• **CLIMATE CONTROL—HIGH PITCHED WHISTLE NOISE FROM THE A/C PLENUM AREA—HIGHWAY SPEEDS ONLY—VEHICLES BUILT 04/04/2001 THROUGH 05/17/2001** • **NOISE—HIGH PITCHED WHISTLE NOISE FROM THE A/C PLENUM AREA—HIGHWAY SPEEDS ONLY—VEHICLES BUILT 04/04/2001 THROUGH 05/17/2001**	**Article No. 01-15-4**

FORD: 2001 CROWN VICTORIA

MERCURY: 2001 GRAND MARQUIS

Figure 1 - Article 01-15-4

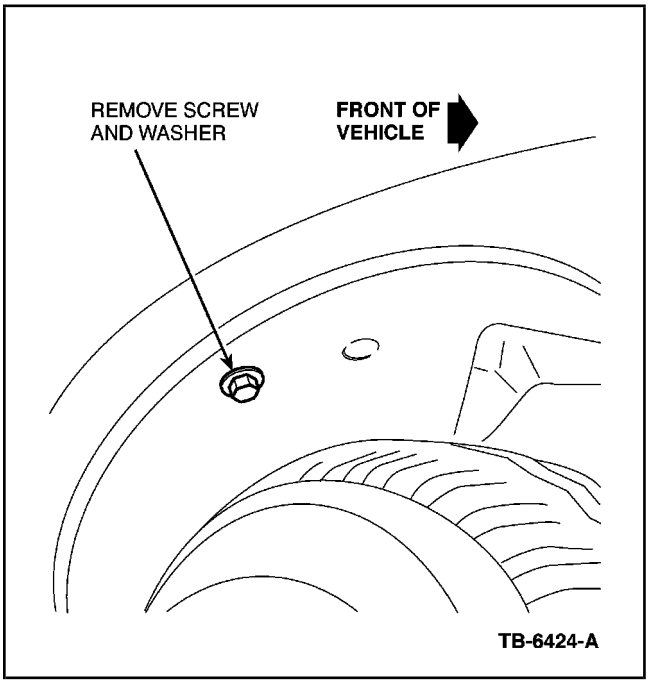
2. Raise vehicle on hoist.
3. Remove right front wheel.
4. Loosen and remove rear fender apron screw (Figure 1).
5. Peel back fender apron to gain access to inlet air duct drain flap (Figure 2).
6. Lift A/C drain flap, 4 molded vertical ribs in the housing should be visible.
7. Cut a notch in rib number 3 (Figure 3). Use a pair of side cutters to cut the notch.
8. Place fender apron back in place.
9. Re-secure fender apron screw (11.5+/- 2.5 N•m).
10. Re-secure wheel to vehicle (115 - 142 N•m).
11. Lower vehicle from hoist.

Figure 3 - Article 01-15-4

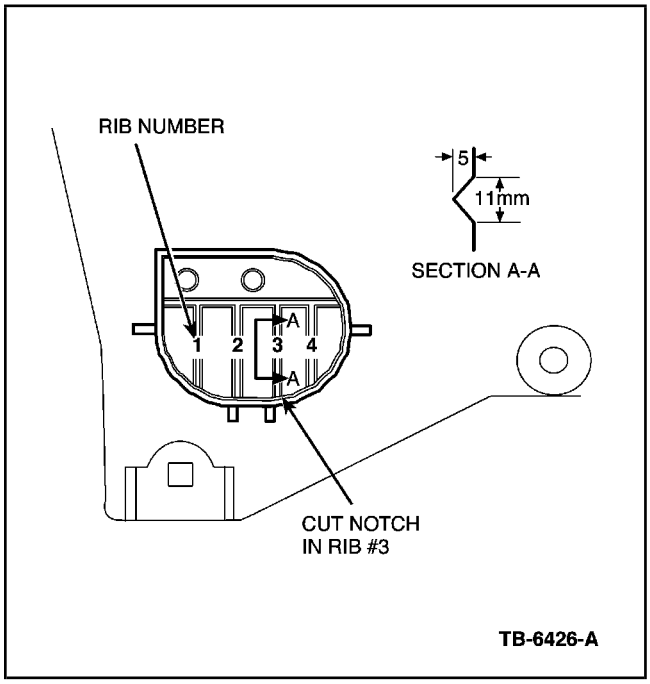
There are 4 molded vertical ribs in the housing behind the A/C drain flap. Cut a notch in rib 3 as shown. Refer to the following Service Procedure for details.

When the air inlet duct door is in the MAX A/C or OFF position, ram air on the fresh air side of the duct is exiting through the drain at the bottom of the duct and then re-entering the drain on the recirculation side of the drain. The air is flowing behind the rubber drain flap and over a molded plastic rib in the housing. The air flow through this narrow gap is generating the whistle noise.
